UNITED STATES  
NUCLEAR REGULATORY COMMISSION  
WASHINGTON, D.C. 20555-0001

SUBJECT: ISSUANCE OF AMENDMENT CORRECTION FOR THE WASHINGTON PUBLIC POWER  
SUPPLY SYSTEM NUCLEAR PROJECT NO. 2 (TAC NO. M88839)

The Commission issued Amendment No. 122 on May 27, 1994, to the Facility Operating License No. NPF-21 for WPPSS Nuclear Project No. 2. The amendment changed the Technical Specifications (TS) in response to your February 17, 1994, application and May 13, 1994, clarification letter.

FIGURE 3.4.6.1.c

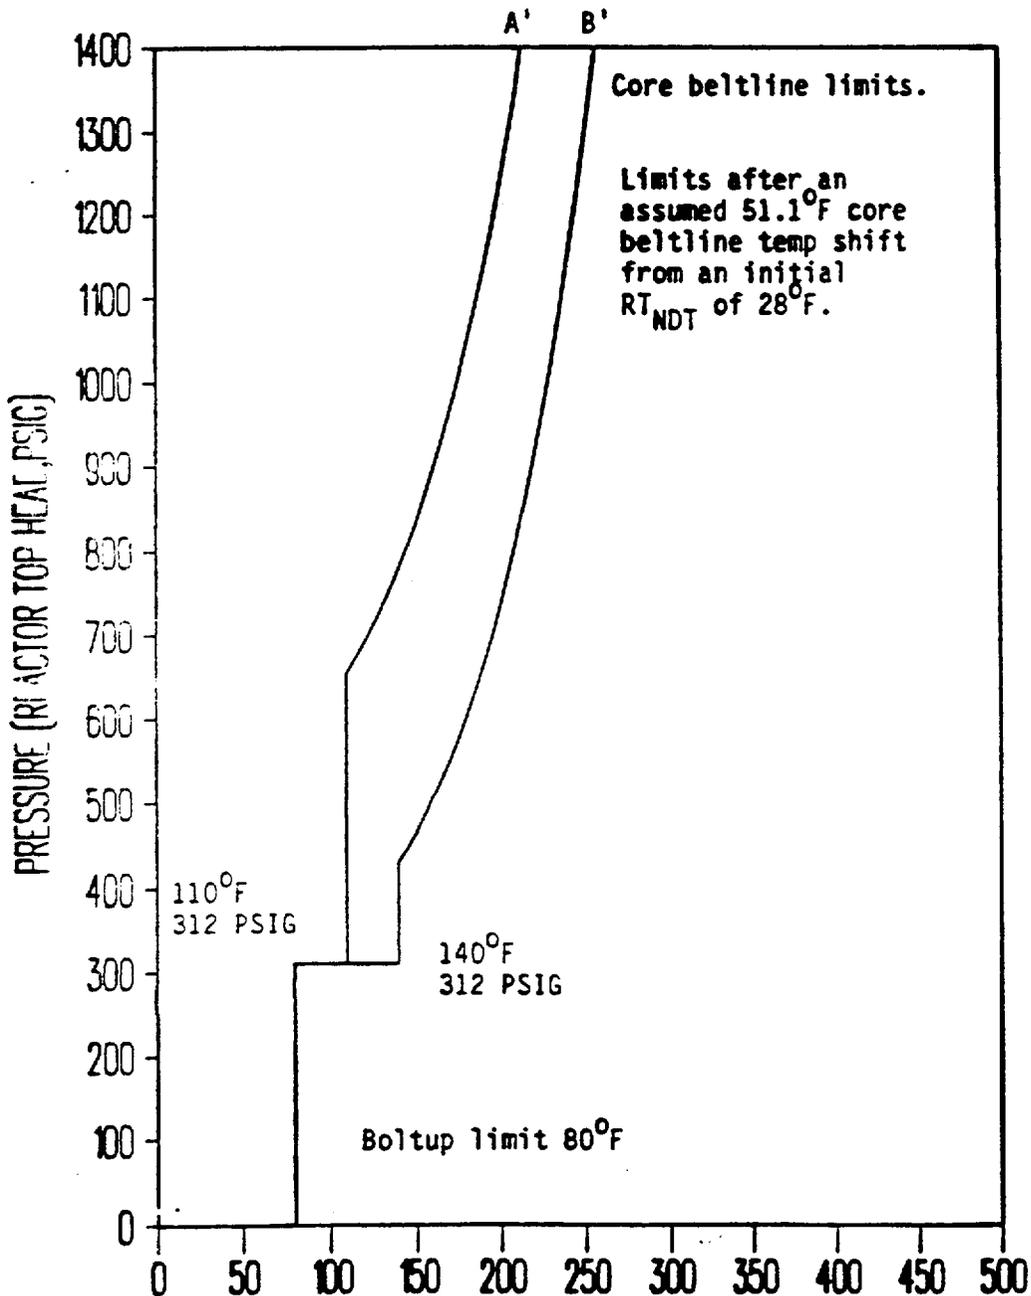
- Page xx(a) was issued with Figure 3.4.6.1.C, "PRESSURE/TEMPERATURE LIMITS FOR 8 EFPY TESTING AND NONNUCLEAR HEATING CURVES," listed as being on page 3/4 4-21b. Page xx(a) has been reissued with the figure listed as being on page 3/4 4-21a.
- Page 3/4 4-21b was issued as a single-sided TS; you agreed that this page should be renumbered as page 3/4 4-21a with page 3/4 4-22 as the overleaf.
- Page B 3/4 4-6 was issued with Bases Table B 3/4.4.6-1, "Reactor Vessel Toughness." You requested that Bases Table B 3/4.4.6-1 be deleted, the words "THIS PAGE IS BLANK INTENTIONALLY" put in the table's place, and the page reissued with overleaf page B 3/4 4-5.
